**FINAL DRAINAGE REPORT FOR
HUNSINGER SUBDIVISION
LOT 10, VAC W 20.0 FT OF OTERO AVE ADJ, BLK B CPRING CREST
AMD FIL - LOT K, VAC W 20.0 FT OF OTERO AVE ADJ, BLK B SPRING
CREST FIL NO 2 – LOT L, VAC W 20.0 FT OF OTERO AVE ADJ, BLK B
SPRING CREST FIL 2
10140 OTERO AVENUE
COLORADO SPRINGS, COLORADO**

OCTOBER 2018

PCD File No. VR-18-014

Markup Summary

GENERAL LOCATION MAP

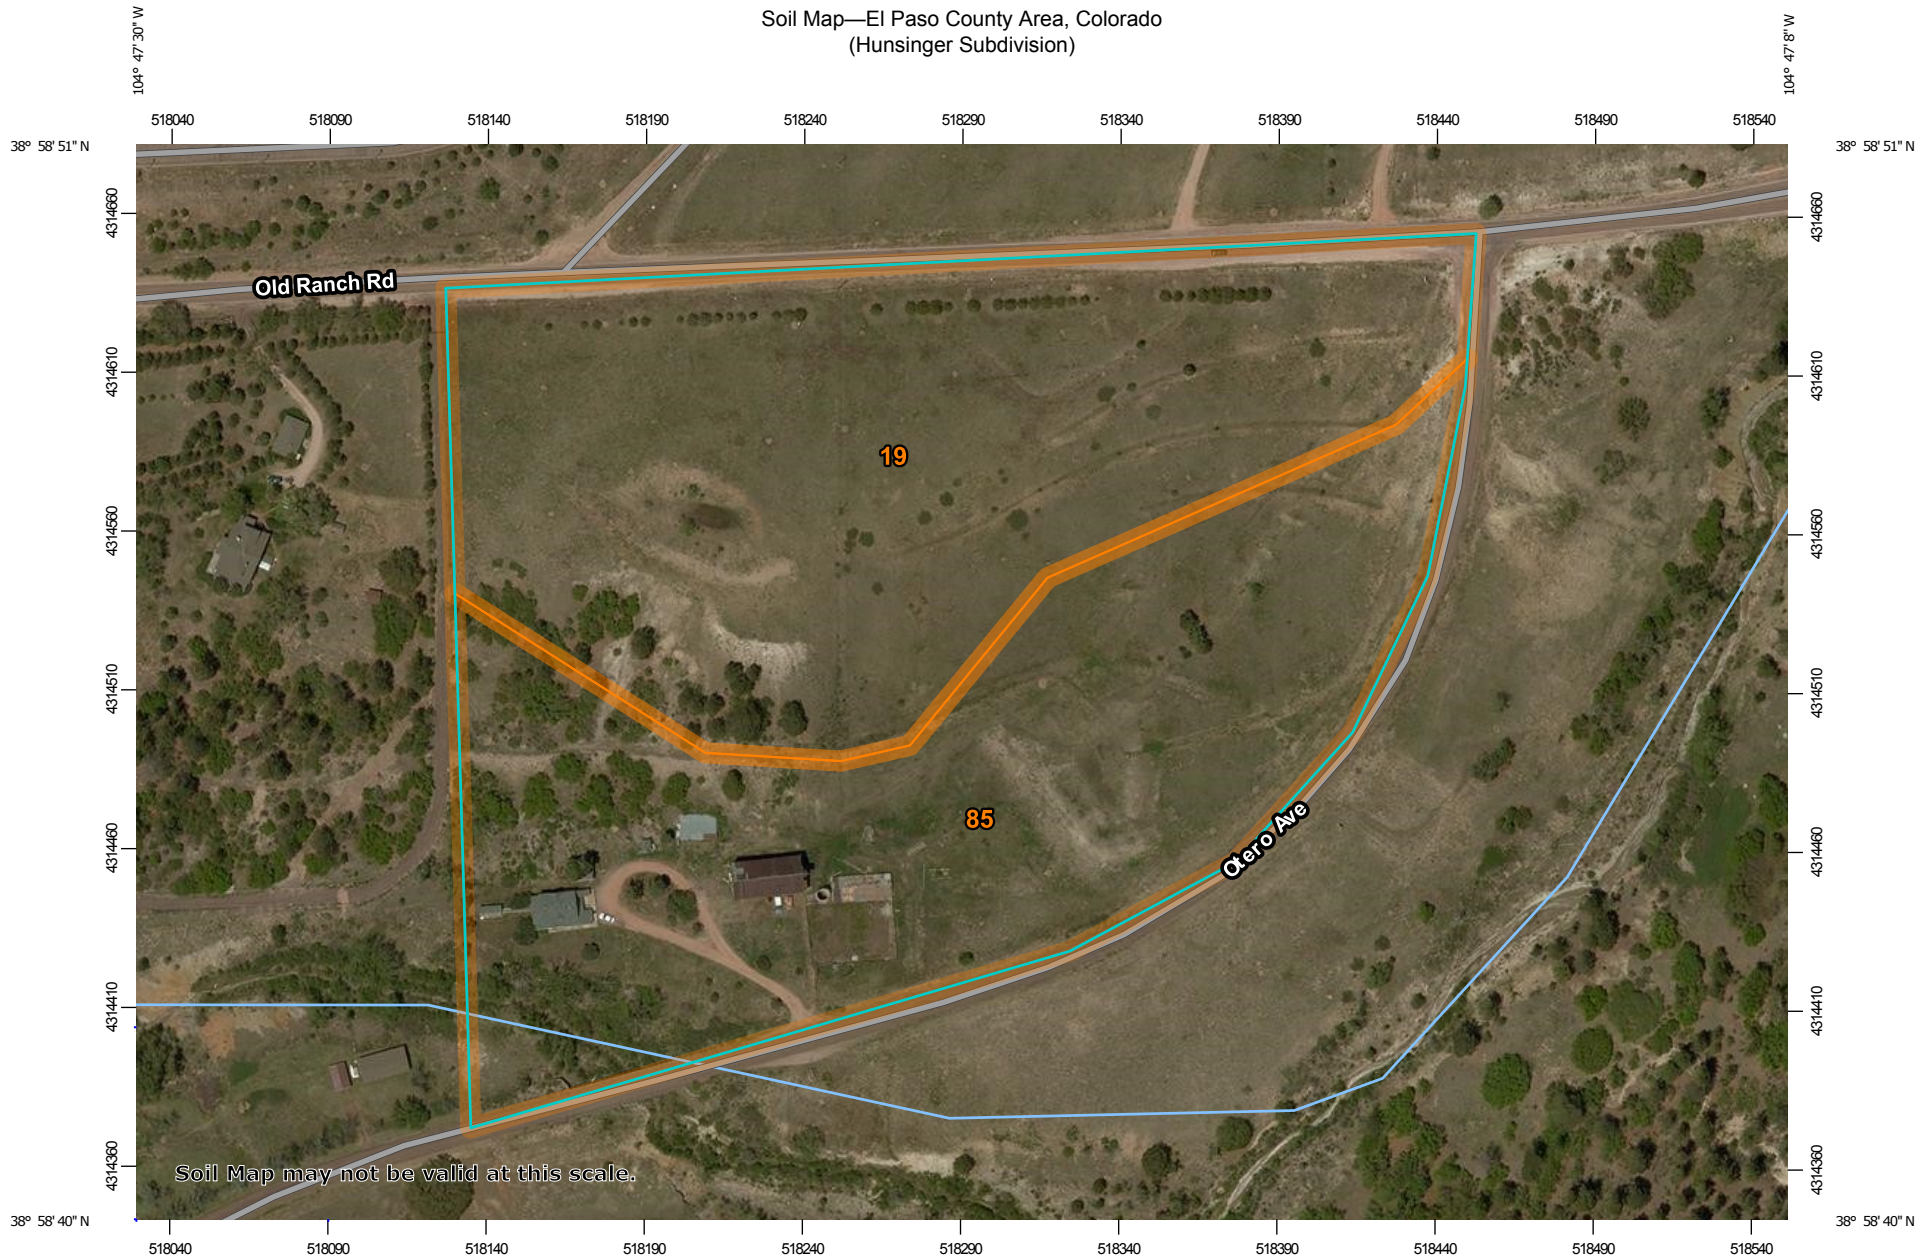
Draw the site location.
